**MR-1413F**

Application	General Data	
<b>Project Name:</b> Six-Story Bioenginerring Building  <b>Site Location:</b> Intersection of Paint Branch Drive and Technology Drive at the University of Maryland at College Park Main Campus  <b>Applicant/Address:</b> 2101 Main Administration Building College Park, MD 20742  <b>Property Owner:</b> University of Maryland Board of Trustees	<b>Planning Board Hearing Date:</b>	12/4/14
	<b>Date Accepted:</b>	09/8/14
	<b>Mandatory Action Timeframe:</b>	60-Day Review Waiver by Applicant.
	<b>Acreage:</b>	2.3 acres
	<b>Zone:</b>	R-R
	<b>Planning Area:</b>	66
	<b>Plan Prince George's 2035:</b>	Employment Area and Innovation Corridor
	<b>Council District:</b>	District 3
	<b>Adjacent Municipality:</b>	College Park

## MR-1413F Staff Report – University of Maryland at College Park Proposed Six-Story Bioenginerring Building

Building Heights proximate to proposed new UMCP Bioengineering Building, with height in stories above grade.

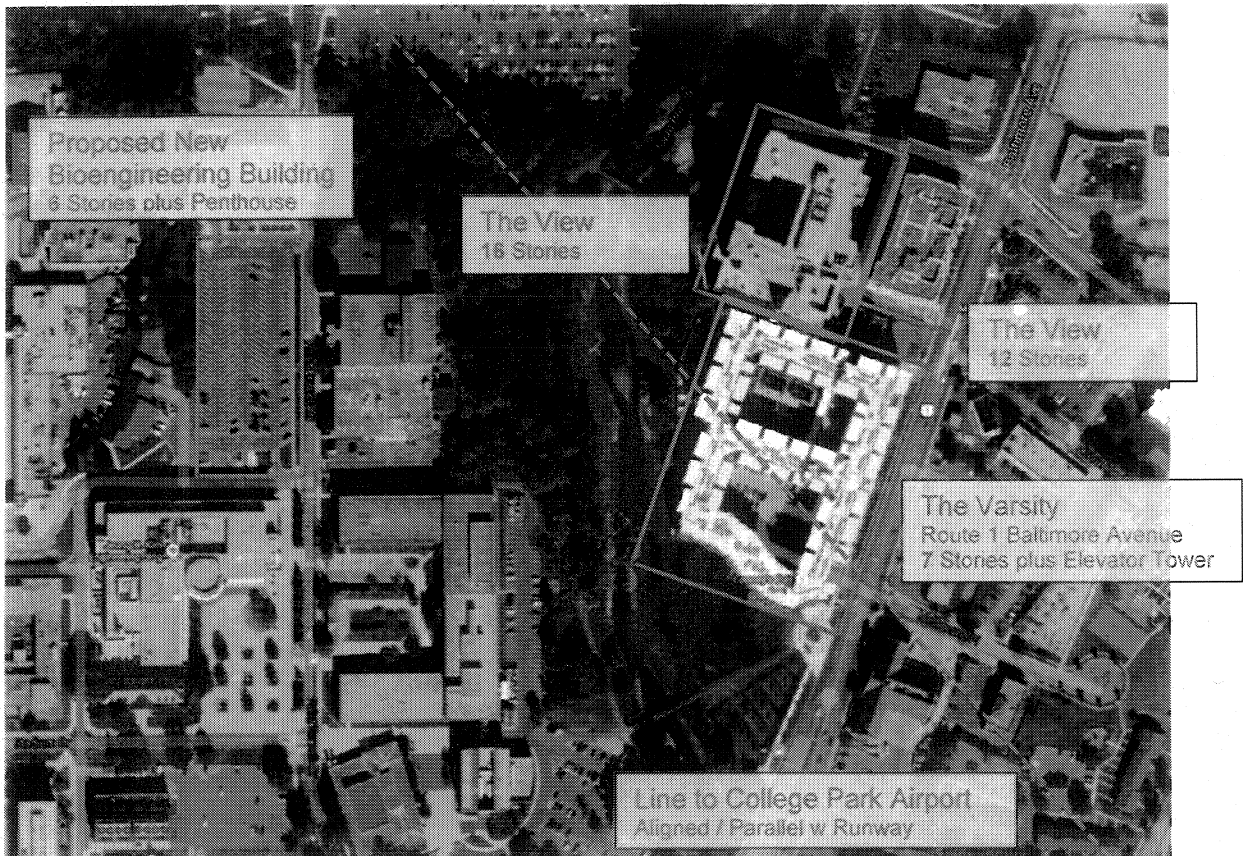
**3. Add other information Ballinger considers pertinent to the justification including existing structures located between the College Park airport and our proposed site.**

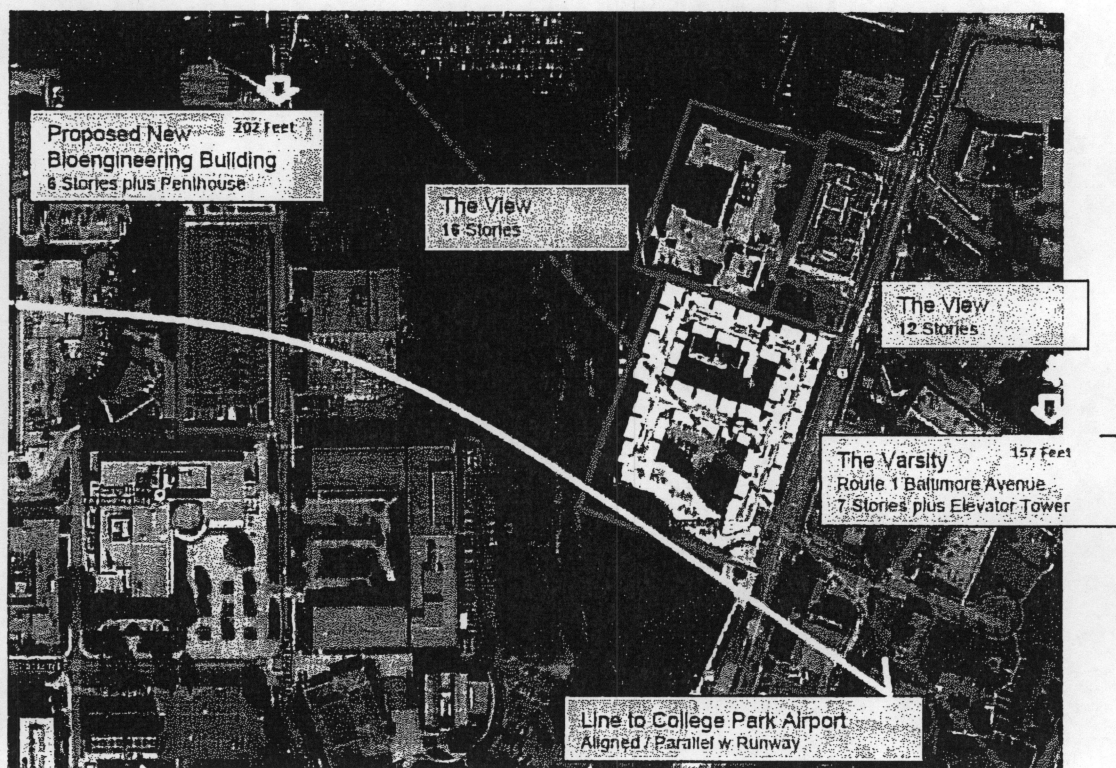
Page 25 (Attachment-3901) doesn't have the height of the building depicted. It has the width but given that the most serious concern is the buildings height it seems odd. This building is much higher than a typical 6 story building.

Page 28 (Attachment-3901) fails to adequately depict the airport environment in that area. It does not show the University View, a building 700 feet to the north and east of the proposed Bioengineering building. This building was declared an obstacle by the FAA. It was declared a hazard by the MAA. Being an obstacle it has to be flown around.

When taking off to the east, most pilots tend to fly just to the south of University View as it sticks up quite a bit. A flight path to the south is typically chosen for number technical reasons that relate to flight. A
